Re: **MPSC Case No. U-20471**

In the matter of the Application of)
DTE ELECTRIC COMPANY for)
approval of its Integrated Resource Plan)
pursuant to MCL 460.6t, and for other relief.)
_____)

**INITIAL BRIEF OF
ENERGY MICHIGAN, INC.**

Chart 1. % CIL Usable to Satisfy MISO PRMR – MISO Current Rules *

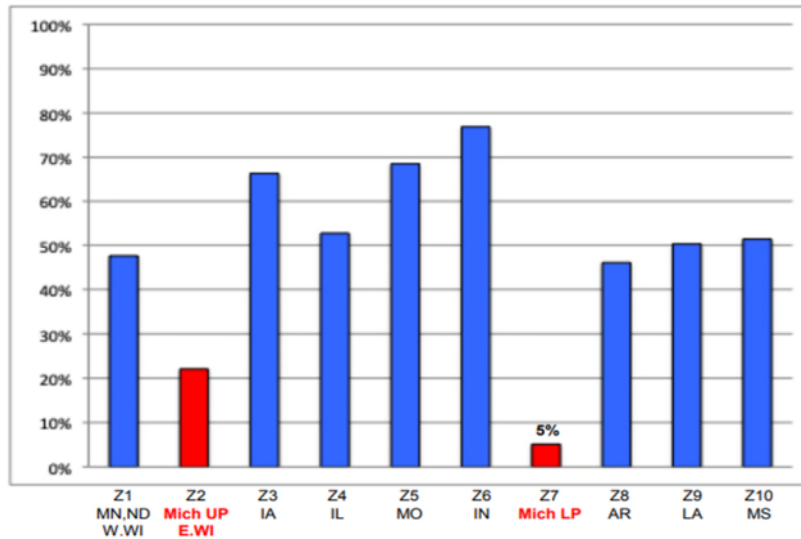
Energy Michigan Witness Alex Zakem shares DTE Electric's and the Commission's concerns regarding the diminishing CIL for Zone 7. In fact, Mr. Zakem noted that while all MISO zones are affected by the CIL, Michigan's Zone 2 and 7 are affected the most. *See* Exhibit EM-2 (AJZ-2), which shows the percentage of ECIL compared to the physical CIL for

all zones. All Zones are well under 100%. But Michigan’s Zone 7 is the lowest, at only 5%, and the

- 100% of CIL is available at the time of the MISO forecast peak – the specified time for determining PRMR obligations.
- But the current LCR process does not allow any zone to use 100% of its CIL to satisfy MISO’s PRMR.
- Zone 7 Michigan Lower Peninsula is an outlier among the zones. Michigan is disadvantaged by the current LCR process.

MI/WI Zone 2 is about 22%.

Per Mr. Zakem, “Michigan Zone 7 at 5% is an obvious ‘outlier’ among the zones, being disadvantaged by the MISO rules to a much greater degree than any of the other zones.” 7 Tr 2952.
